Spare Parts Requirements - Transfer Case/Transfer Case Control Unit: Note link between transfer case and control unit software (26/18)

Model Line: **Macan**

Model Year: **As of 2015 up to 2018**

Subject: **Transfer case and transfer case control unit** (all-wheel drive control unit)

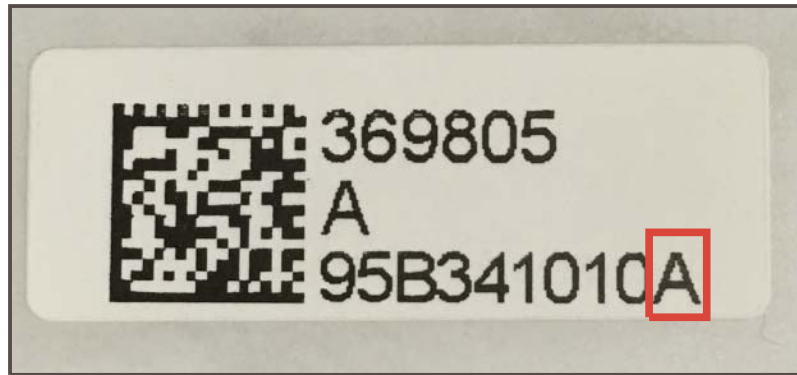
"Gas nitrocarburizing (GNC)" is now used to coat the clutch plates on the transfer case.

The software in the related transfer case control unit must be updated accordingly.

⇒ A mixed installation – transfer case with GNC plates and control unit software with an old data version or vice versa – is not permitted.

Transfer case without GNC (old)	Transfer case with GNC – NEW –
Display in the PIWIS Tester: ⇒ Porsche Part No. of control unit • after commissioning:	95B.927.755.BJ	95B.927.755. CB

Display in the PIWIS Tester: ⇒ Software version of control unit • after commissioning	1204	1360
Display in the PIWIS Tester: ⇒ Porsche hardware Part No. of control unit • before commissioning	95B.927.755.B	95B.927.755.C
Display in the PIWIS Tester: ⇒ Porsche hardware Part No. of control unit • after commissioning	95B.927.755.BJ	95B.927.755. CB
- Sticker on transfer case (⇒ <i>Sticker with part number</i>) - lasered on the underside	95B.341.010	95B.341.010. A
Display in the PIWIS Tester: ⇒ PR number* in the vehicle order (Additional menu)	- without -	LU2 - Transfer gear reinforced
Porsche Spare Parts Catalog (PET2)	95B.341.010	95B.341.010. A

Transfer case with control unit

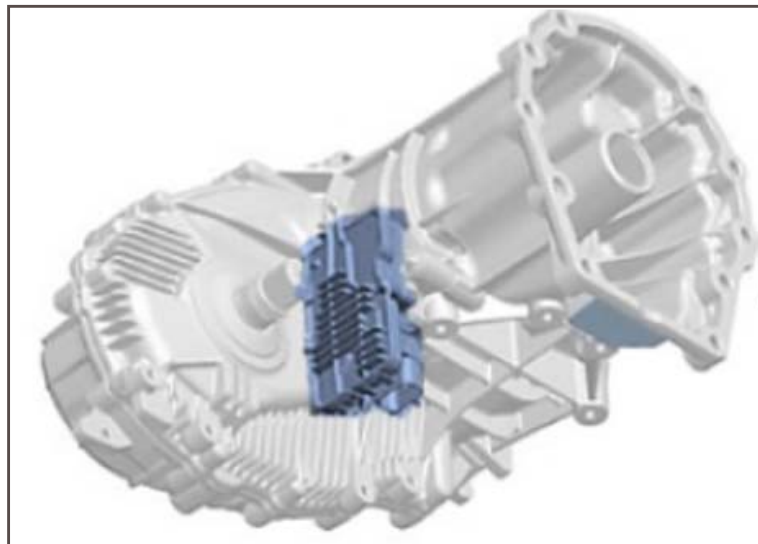
Variant 1: **Replacing transfer case and transfer case control unit** (together, ⇒ *Transfer case with control unit*).

The relevant transfer case control unit is already fitted on a new transfer case. **PIWIS Tester 3** selects the correct data record and sets the PR number LU2 automatically.

Sticker with part number

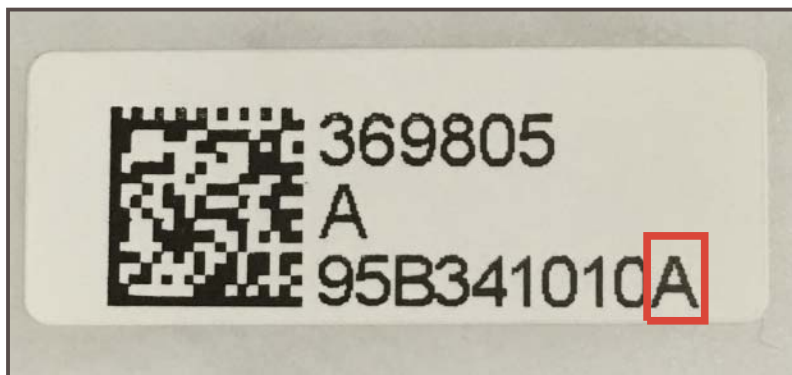
Part number on the new (replacement/reconditioned) transfer case (sticker with part number ⇒ *Sticker with part number*)

- a) **Part number** of the new **transfer case does not correspond to the new type** ⇒ **Part number ends with 010 and has no index** (no letter, e.g. "A")

- b) Part number of the new transfer case corresponds to the new type ⇒ **Part number has index letter ("A")**

⇒ **The transfer case on the new PDK must be replaced by a transfer case with the new part number (with index letter).**

⇒ **The transfer case can remain on the new PDK and can be installed in the vehicle.**
